Subject: **Taft Recycling, Inc., TS/MRF-WPF**
Modification of SO48-0173968-002
Permit Application No. SO48-0173968-004
Project No. 04-297.001

On behalf of Taft Recycling, Inc. (Taft), HSA Golden is responding to your comment letter on the subject Waste Processing Facility (WPF) permit modification application dated October 26, 2004. Hereafter, we restate your comments and respond accordingly.

Orange County - SW
Taft Recycling, Inc., TS/MRF-WPF
Modification of SO48-0173968-002
Permit Application No. SO48-0173968-004

TO: George Cheryan 
THROUGH: Jim Bradner, P.E.
FROM: Deborah Helle, P.G. 
DATE: October 14, 2004
SUBJECT: Taft Recycling RAI Response Review

**CLASS I & III WPF
 PROPOSED SITE PLAN**

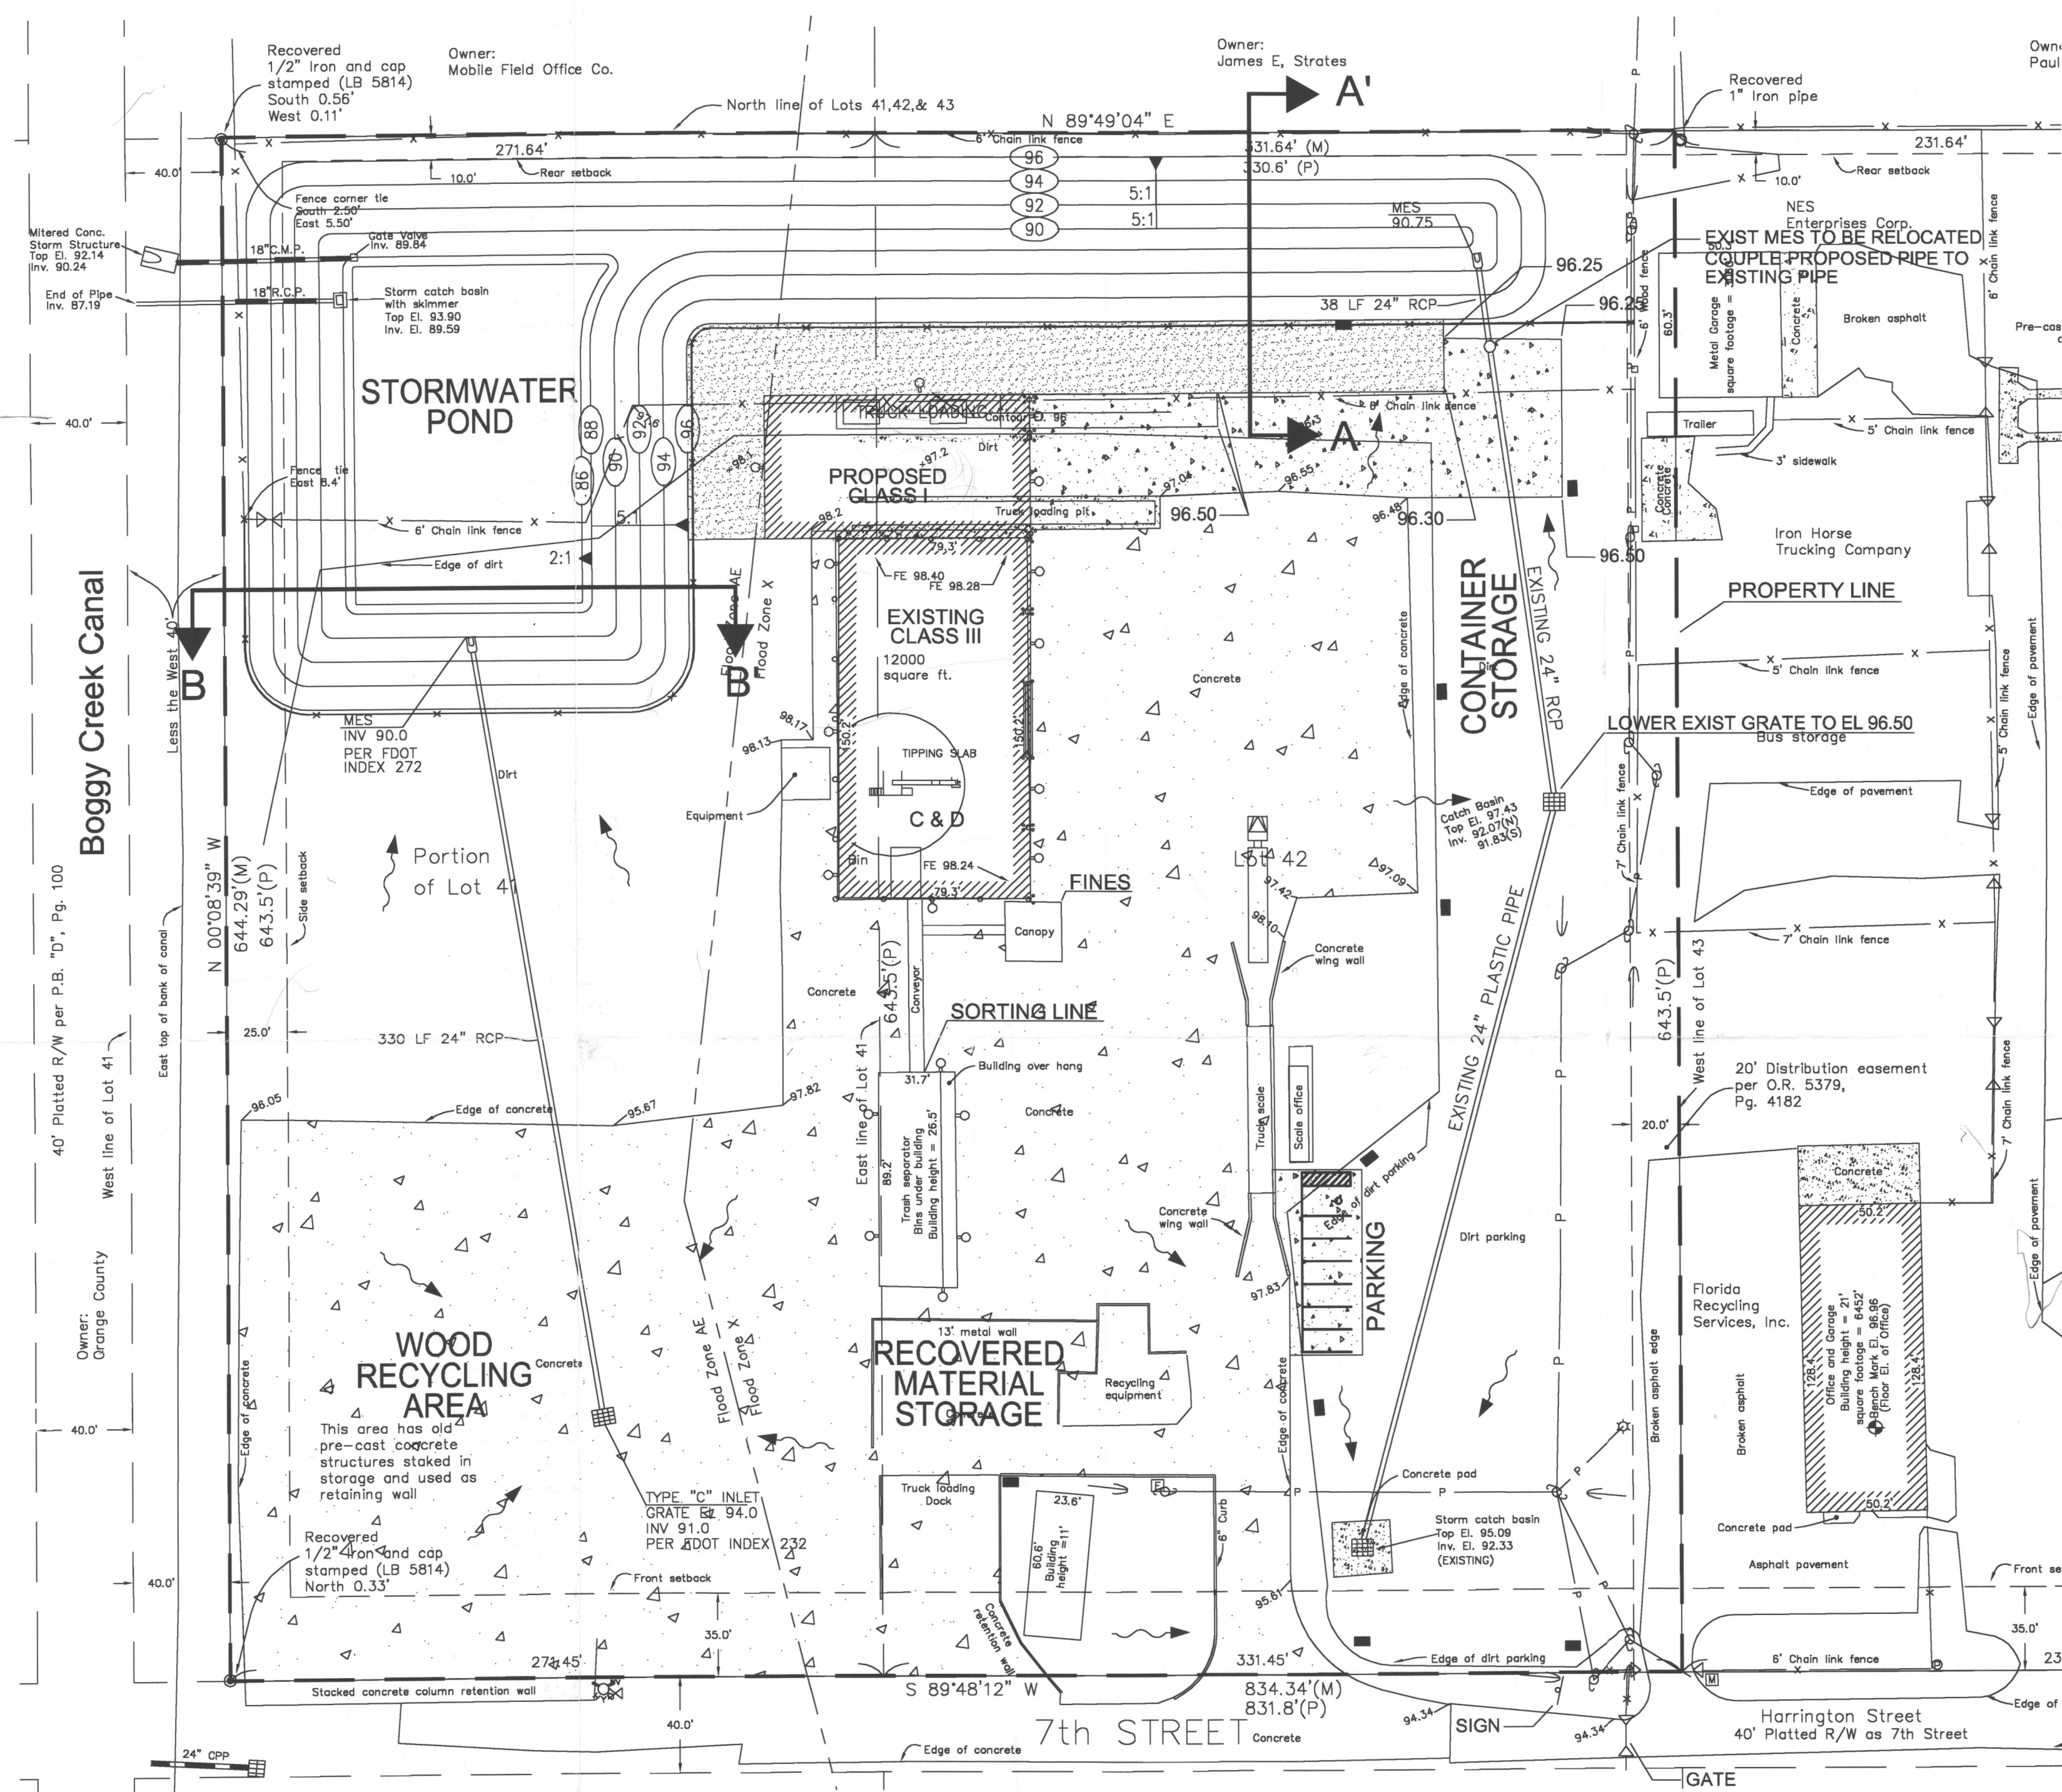
Comment 3: The site plan in Attachment D of the Permit Modification Application does not show relevant features such as water bodies or wetlands on or within 200 feet of the site, potable water wells on or within 500 feet of the site, and wells serving

community public water supplies on or within 1,000 feet of the site, as required in Item B-2 on Page 3 of 4, DEP Form #62-701.900(4). Comment and make any necessary revisions to the site plan.

3. The site plan in Attachment D of the Permit Modification Application does not show relevant features such as water bodies or wetlands on or within 200 feet of the site, potable water wells on or within 500 feet of the site, and wells serving community public water supplies on or within 1,000 feet of the site, as required in Item B-2 on Page 3 of 4, DEP Form # 62-701.900(4). Comment and make any necessary revisions to the site plan.

The information required under form no. 62-701.900(4) was provided in the original 2000 submittal and has not changed. However, we have added the relevant features requested on the revised Site Plan, Appendix I, drawing C-1. In addition, a wetlands map is attached, Figure 1. There are no water bodies, wells or wetlands on site. The site was a borrow pit in the 1970s and was reclaimed in the 1980s. Boggy Creek is adjacent to the site to the west.
